# **TRANSIT EFFECTIVENESS PROJECT Responses to Comments**

**City and County of San Francisco Planning Department  
Case No. 2011.0558E**

DATE: March 13, 2014  
TO: Members of the Planning Commission and Interested Parties  
FROM: Sarah B. Jones, Environmental Review Officer  
Re: **Attached Responses to Comments on Draft Environmental Impact Report Case No. 2011.0558E Transit Effectiveness Project**

**RESPONSES TO COMMENTS  
TRANSIT EFFECTIVENESS PROJECT  
PLANNING DEPARTMENT CASE NO. 2011.0558E**

(New) FIGURE 8a - TTRP.L TARAVAL STREET AND 44TH AVENUE IMPROVEMENTS

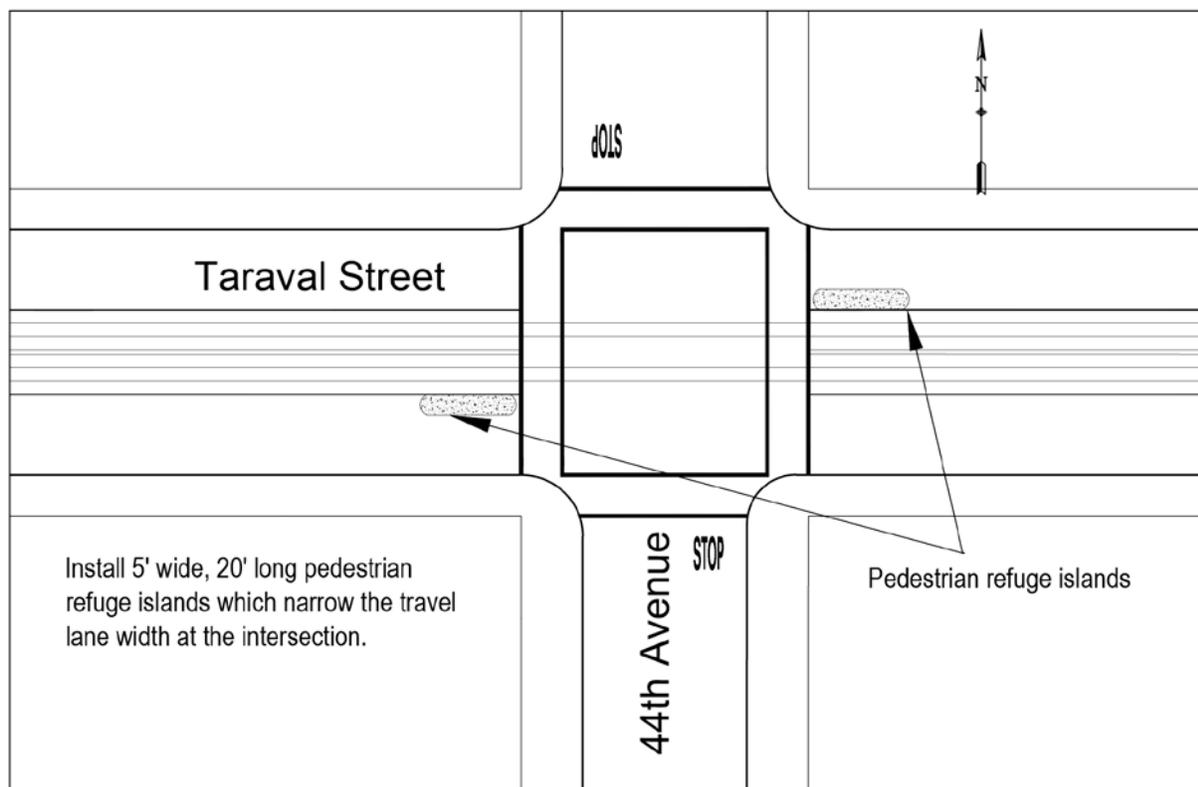
**Pedestrian Improvements (Moderate):** On Taraval Street at 44<sup>th</sup> Avenue, a five-foot-wide, 20-foot-long pedestrian refuge island would be added between the mixed-flow travel lane and the transit-only lane in the inbound and outbound directions. Figure 8a shows the proposed change.

(New) FIGURE 8b - TTRP.L TRAFFIC CALMING AT ULLOA STREET AND 15TH AVENUE EXPANDED ALTERNATIVE

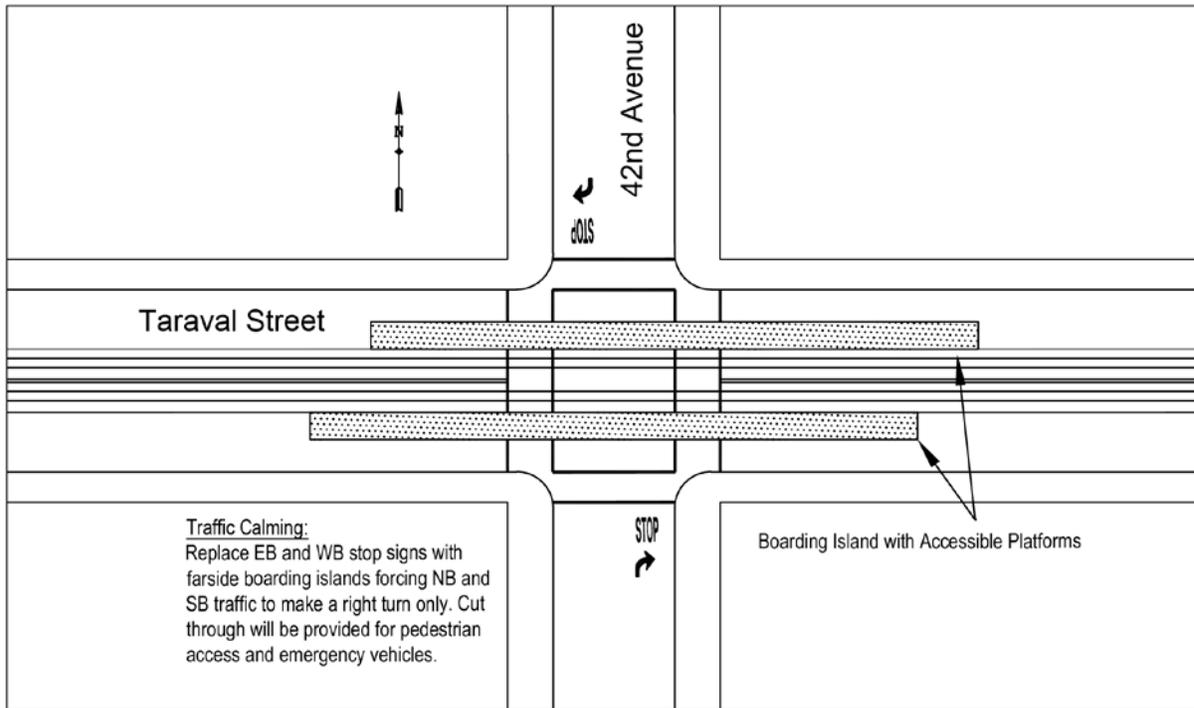
Ulloa Street/15<sup>th</sup> Avenue: A traffic calming, channelizing island would be added in the intersection which would eliminate all through movements forcing a right turn only for all directions, except for southbound traffic, which would be required to make either a right turn or left turn. Figure 8b shows the proposed change for this intersection.

(New) FIGURE 8d - TTRP.L EXPANDED ALTERNATIVE

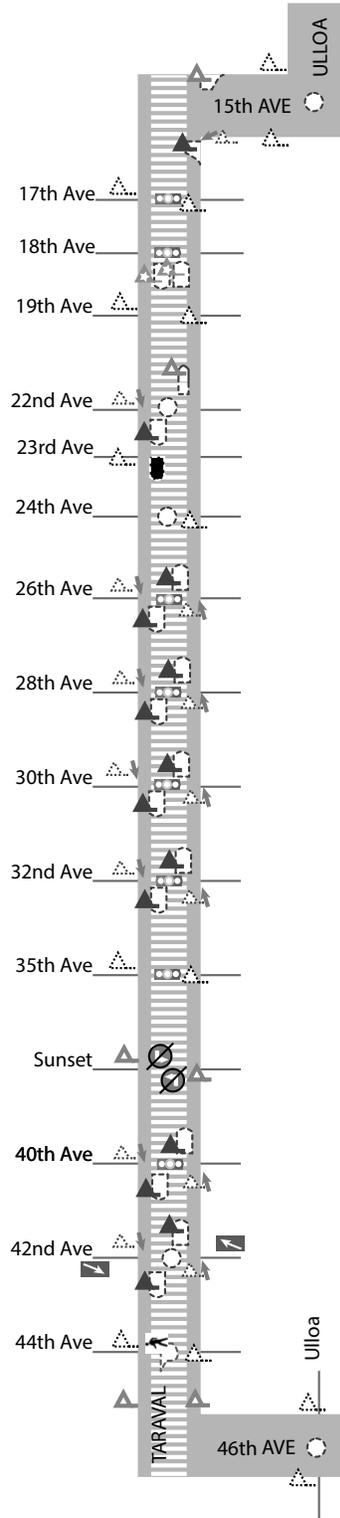
Figure 8d shows the TTRP.L Expanded Alternative and narrative text describes the difference between the Moderate and Expanded Alternatives.

(Revised) FIGURE 11 - TTRP.5 EXPANDED ALTERNATIVE

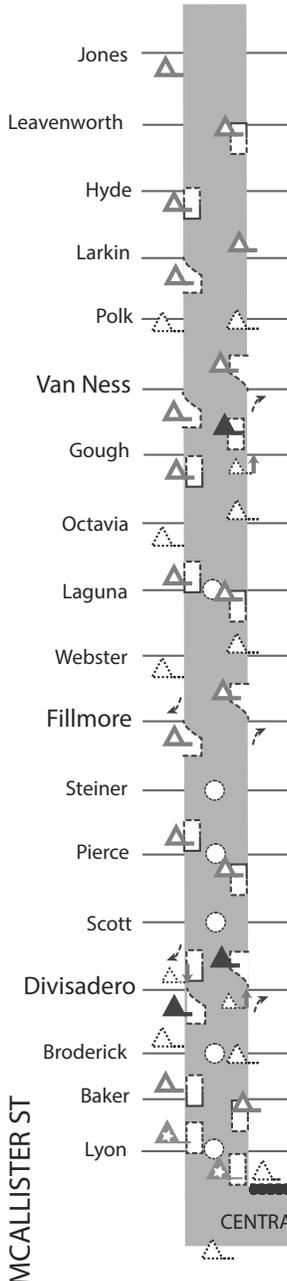
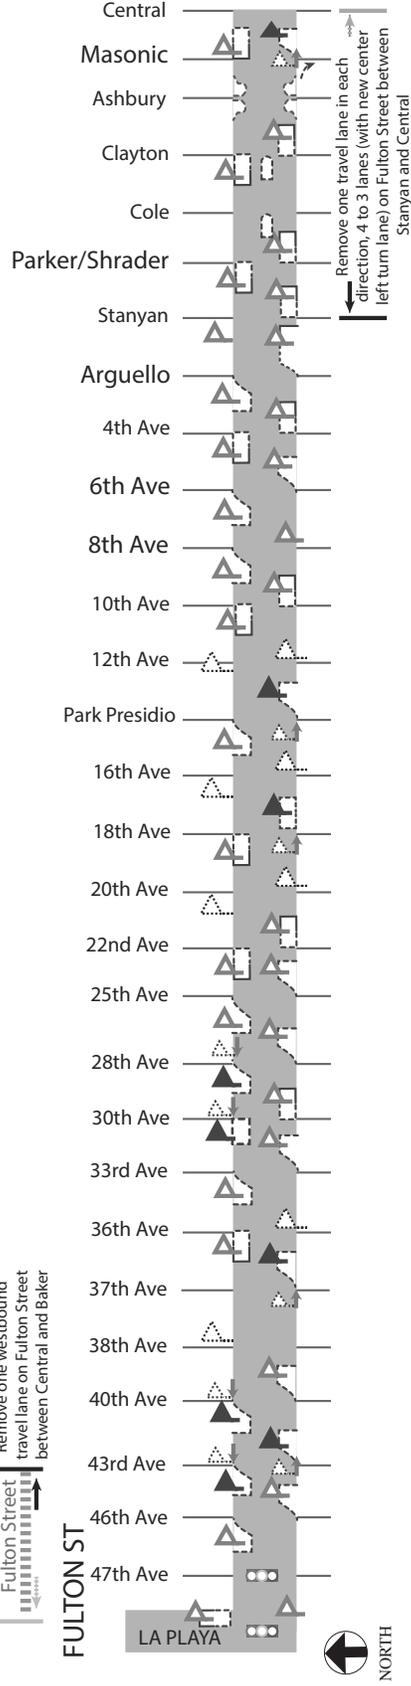
Figure 11: TTRP.5 Expanded Alternative on EIR p. 2-128 has been revised to show that under the Moderate and Expanded Alternatives new inbound and outbound stops would be located at McAllister and Lyon streets, and that one westbound travel lane on Fulton Street (between Central Avenue and Baker Street) would be removed as part of the Expanded Alternative only. Additionally, text on the figure describing how the Moderate Alternative would differ from the Expanded Alternative has been revised to indicate the following: the existing inbound and outbound bus stops at McAllister and Divisadero streets would remain nearside and would be expanded, and right-turn pockets would not be added to McAllister Street at Divisadero Street. Revised Figure 11 is shown on the following page.

Remove one westbound travel lane on Fulton Street between Central and Baker

(Revised) FIGURE 23 - TTRP.30 EXPANDED ALTERNATIVE

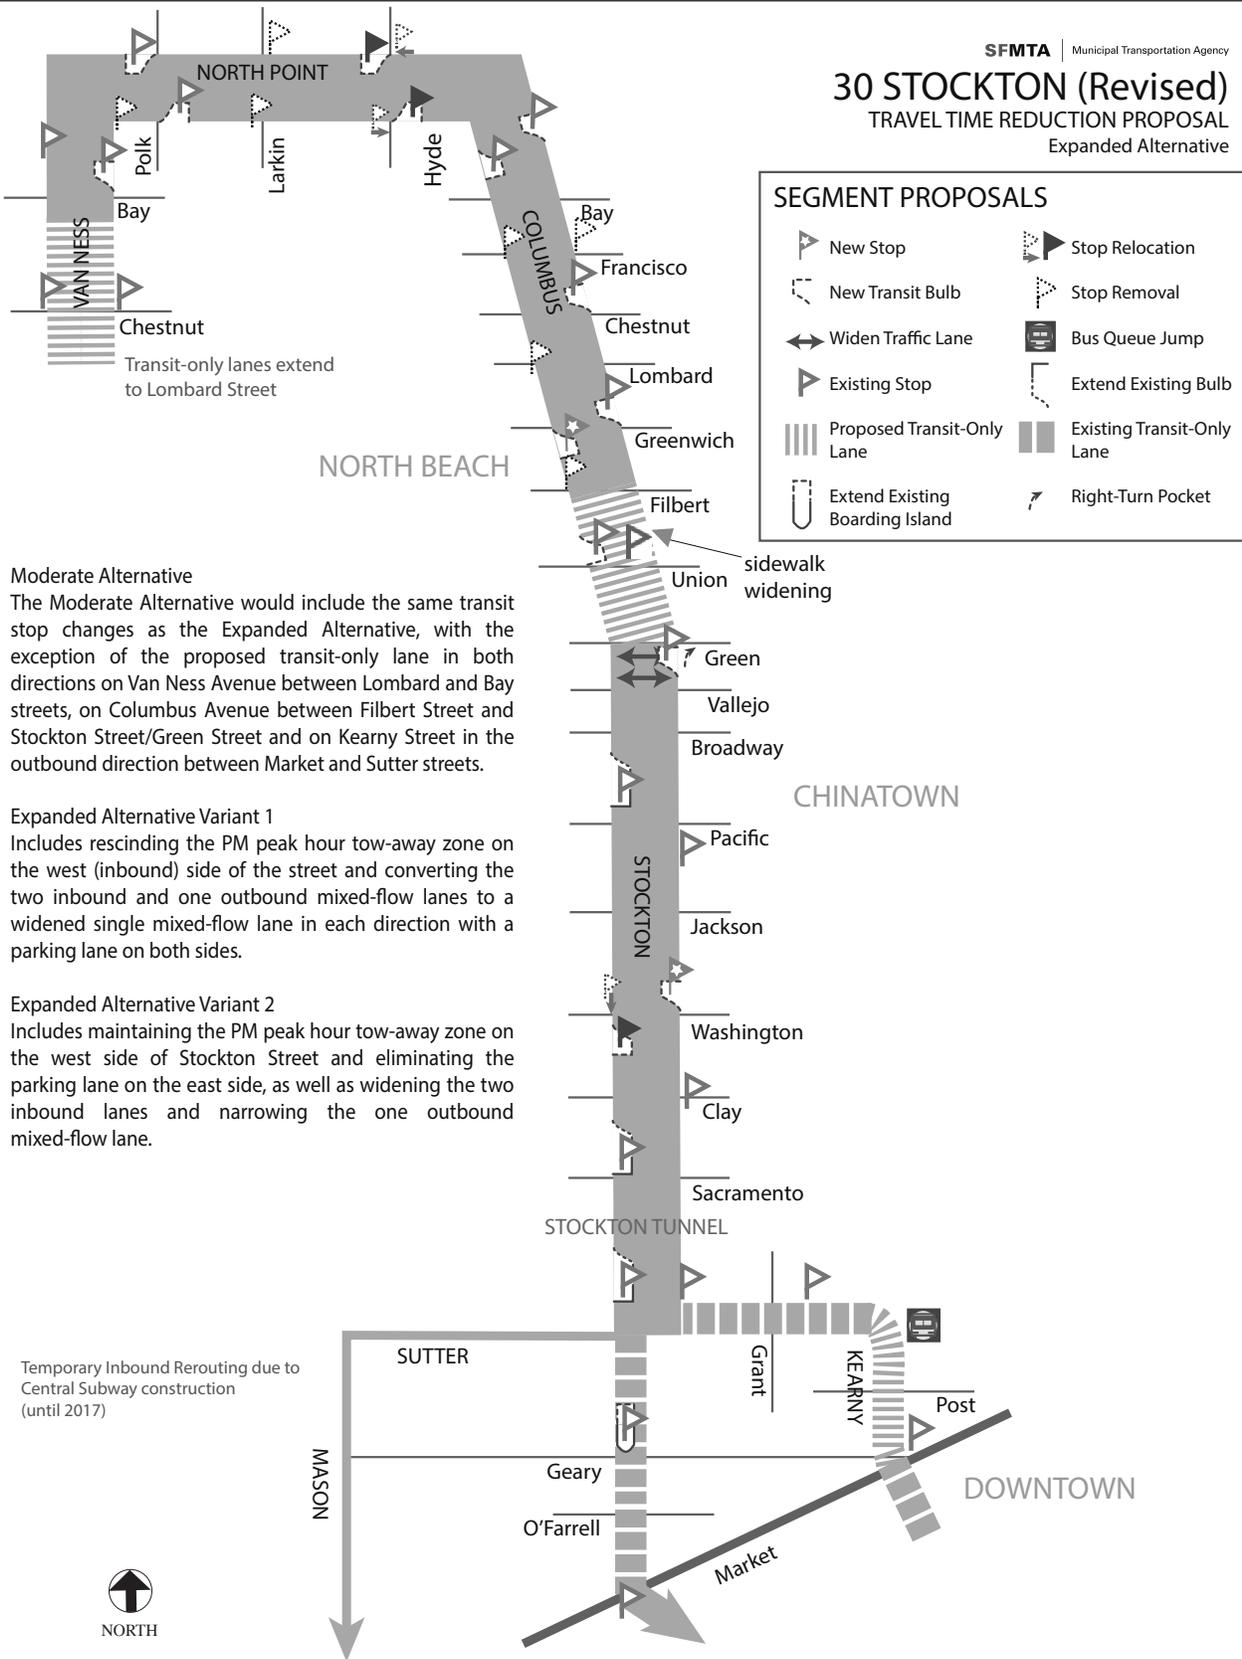
Figure 23: TTRP.30 Expanded Alternative on EIR p. 2-160 has been revised to show that under the Moderate and Expanded Alternatives sidewalk widening would occur on the east side of Columbus Avenue on the entire block between Union and Powell streets. Revised Figure 23 is shown on the following page.

(New) FIGURE 23a - TTRP:71\_1 EXPANDED ALTERNATIVE

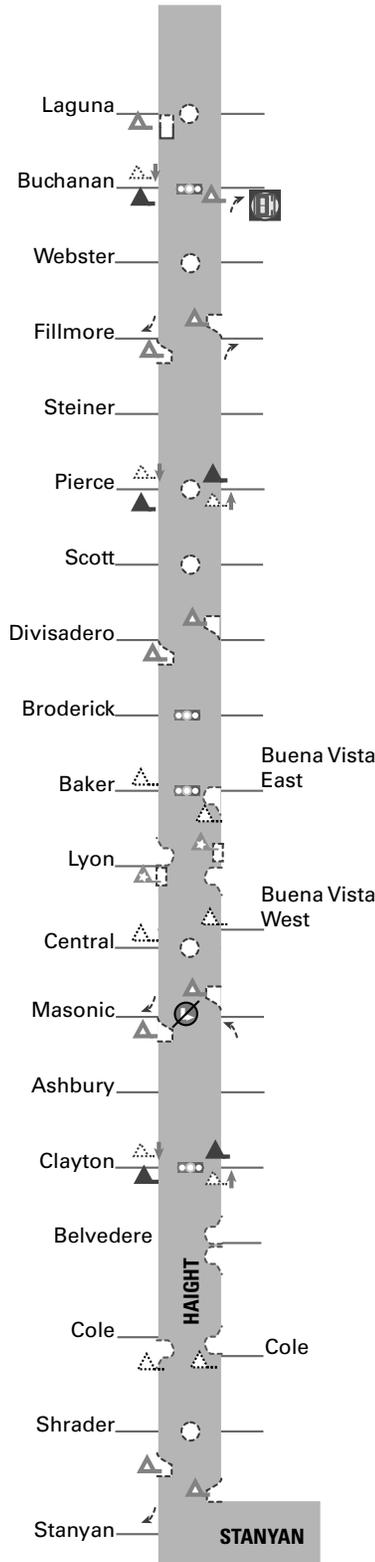
Figure 23a shows TTRP.71\_1 Expanded Alternative and describes the differences between the Moderate and Expanded Alternatives. Please see information and additional graphics illustrating the TTRP.71\_1 project at the SFMTA Web site, online at <http://www.sftfep.com>.

(New) FIGURE 8a - TTRP.L TARAVAL STREET AND 44TH AVENUE IMPROVEMENTS

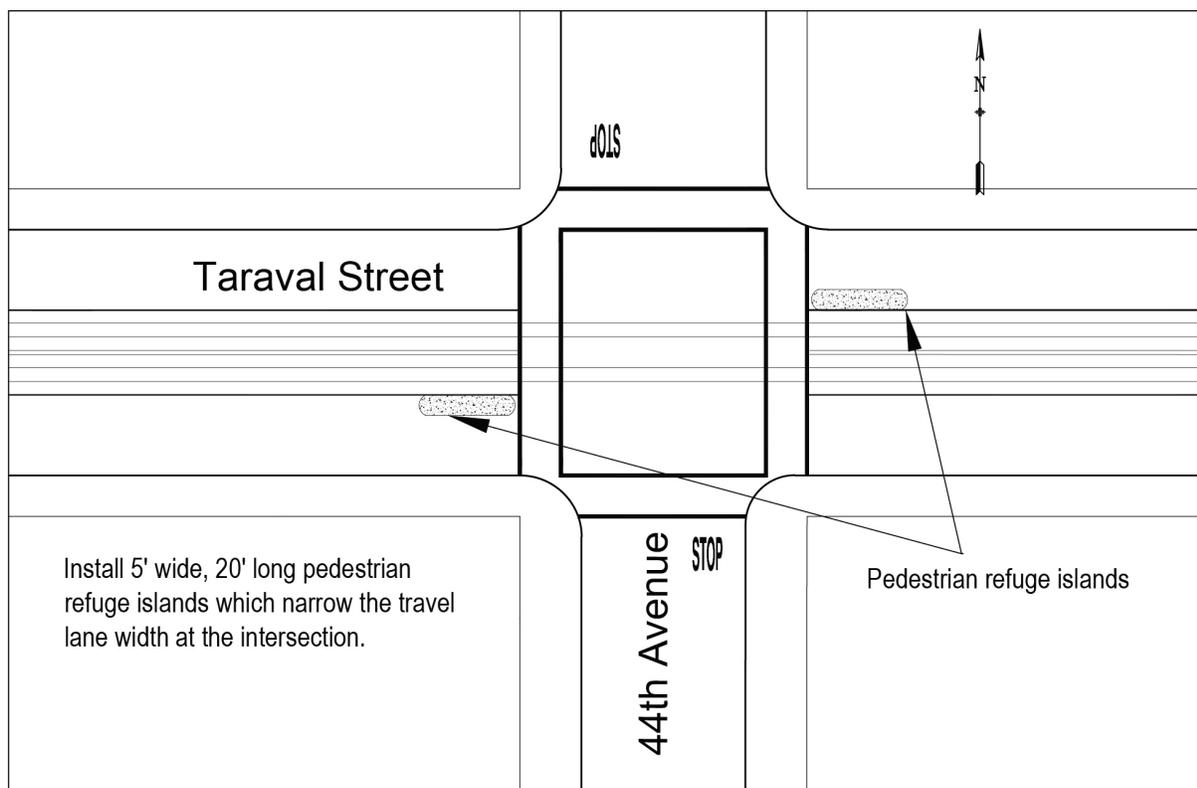
flow travel lane and the transit-only lane in the inbound and outbound directions. Figure 8a shows the proposed change.

(New) FIGURE 8c - TTRP.L TRAFFIC CALMING AT TARAVAL STREET AND 42ND AVENUE EXPANDED ALTERNATIVE

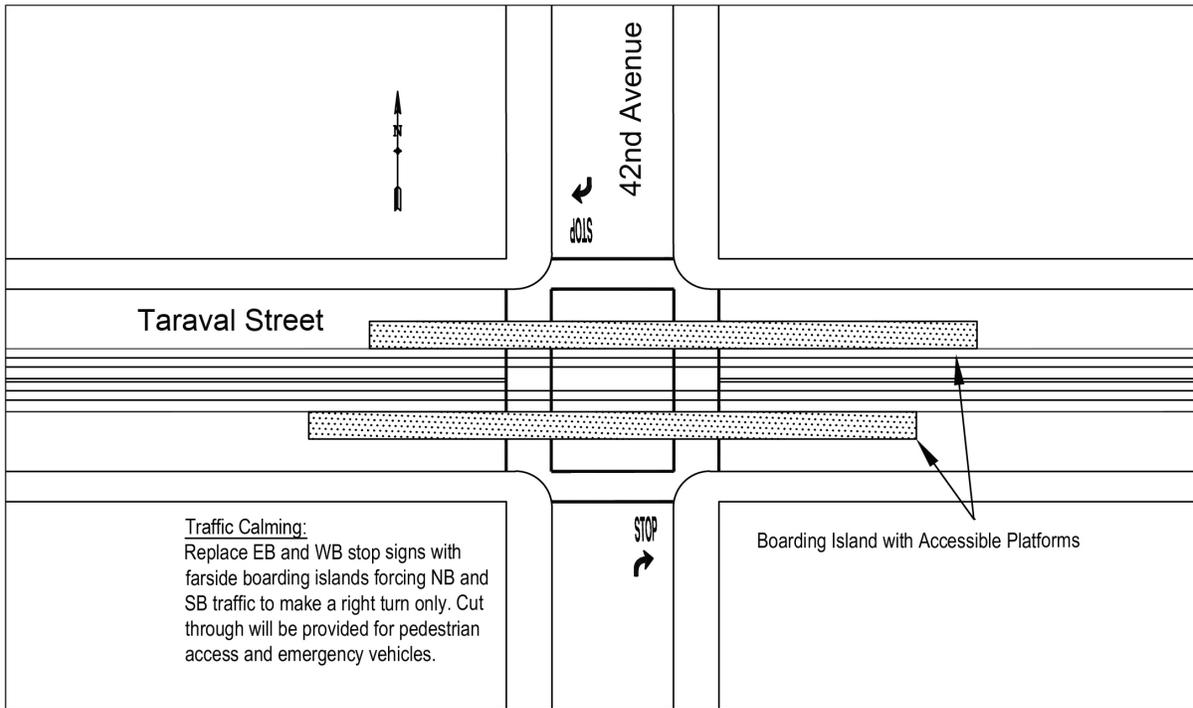
Taraval Street/42<sup>nd</sup> Avenue: On Taraval Street, two 9-foot-wide, 150-foot-long transit boarding islands would be installed and extended through the intersection to serve both inbound and outbound directions. Right-turn only restrictions would be added on 42<sup>nd</sup> Avenue for northbound and southbound traffic. The islands would be designed with a low profile cut-out in the middle that would be wide enough for emergency vehicles to continue through the intersection. Figure 8c shows the proposed change.

(New) FIGURE 8d - TTRP.L EXPANDED ALTERNATIVE

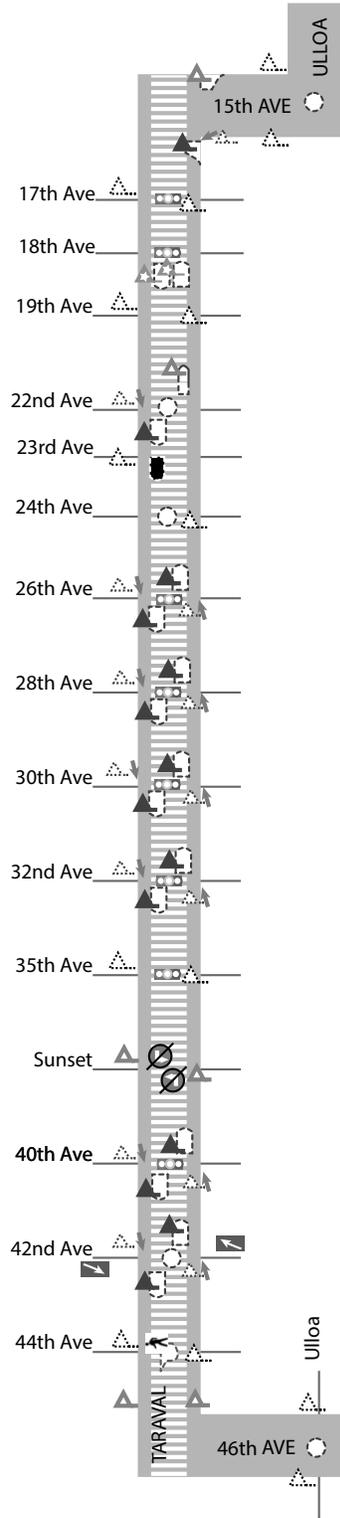
Figure 8d shows the TTRP.L Expanded Alternative and narrative text describes the difference between the Moderate and Expanded Alternatives.

(Revised) FIGURE 11 - TTRP.5 EXPANDED ALTERNATIVE

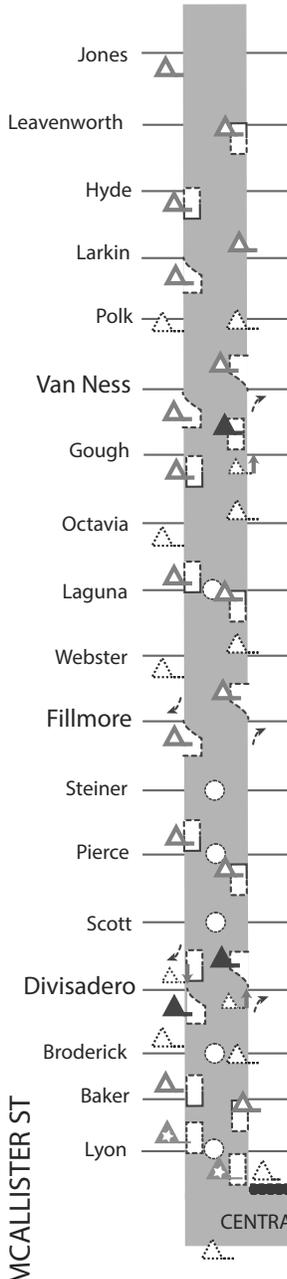
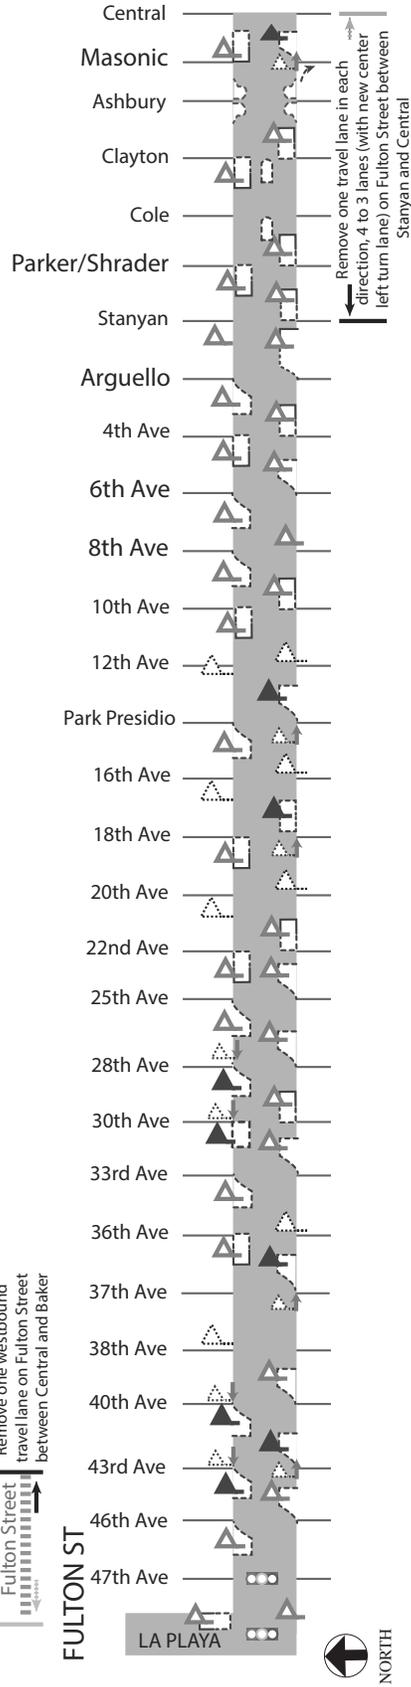
Figure 11: TTRP.5 Expanded Alternative on EIR p. 2-128 has been revised to show that under the Moderate and Expanded Alternatives new inbound and outbound stops would be located at McAllister and Lyon streets, and that one westbound travel lane on Fulton Street (between Central Avenue and Baker Street) would be removed as part of the Expanded Alternative only. Additionally, text on the figure describing how the Moderate Alternative would differ from the Expanded Alternative has been revised to indicate the following: the existing inbound and outbound bus stops at McAllister and Divisadero streets would remain nearside and would be expanded, and right-turn pockets would not be added to McAllister Street at Divisadero Street. Revised Figure 11 is shown on the following page.

Remove one westbound travel lane on Fulton Street between Central and Baker
